PROPERTY INFORMATION	Brickyard Village Preliminary PD
APPLICANT	Barge Design on behalf of Edens Land Corp & KEDB
DISTRICT, LAND LOT OVERLAY DISTRICT	11th Civil District, Map 046P, Group F, a portion of Parcel 009.00 Not Applicable
EXISTING ZONING	PD
PROPOSED ZONING	N/A
ACRES	+/-53.44
EXISTING USE	Vacant
PROPOSED USE	Mixed Residential (Single Family, Townhome, and Apartments)

The applicant is requesting Amended Preliminary Planned Development plat approval for the Brickyard Village development located off of Martin Luther King Jr. Drive on Brickyard Park Drive.

Variance Letters for the Local Cross Section and Short Dead End Street

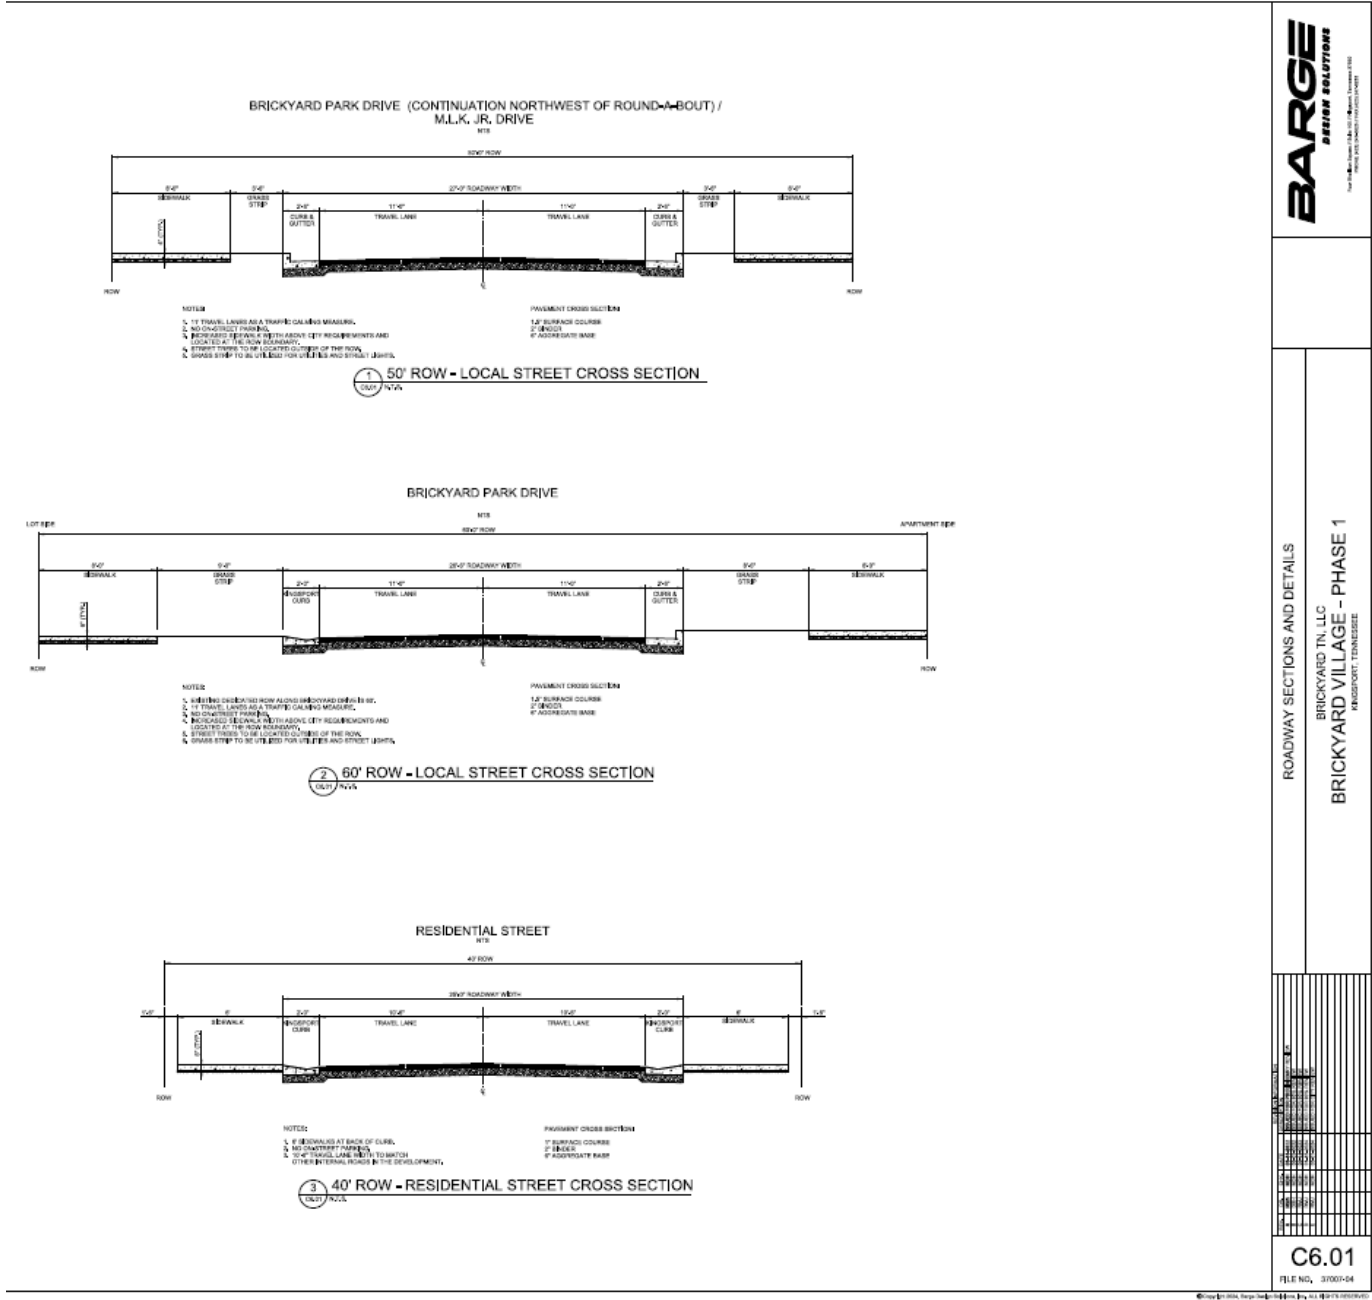
The plan shows the required 25’ periphery setback as well as the areas designated for open space. 24.96 acres is dedicated to open space resulting in a total of 46.71% open space. This percentage of open space qualifies the development for 10 units per acre. The proposed density is 9.06 units per acre.

There is a requested variance for a modified local street cross section and shorter than allowed dead end street.

The modified local street section is proposed for the portion of Brickyard Park Drive that extends up to the proposed roundabout. Due to the northwest side of Brickyard Park Drive for this portion fronting single family homes, the Kingsport Curb is proposed on this side of the cross section to facilitate driveway access. The variance adds the grass strip between the Kingsport Curb and the sidewalk of 9’.

Dead end streets, per the minimum subdivision regulations, must be 150’ in length. The proposed termination of Diamond Way, after intersecting with Jewell Lane, is proposed to be 113-8”. The shorter than required length is due to an existing power line easement and lining up Jewell Lane with the proposed driveway opposite its connection to Martin Luther King Jr. Drive. The variance is for 36-6” of relief to the length of a dead end street.

Staff recommends granting amended preliminary PD plan approval for Brickyard Village contingent upon the approval of the construction plans, the modified local street cross section with 9' grass strip, and the 36' 6" dead end street variance.
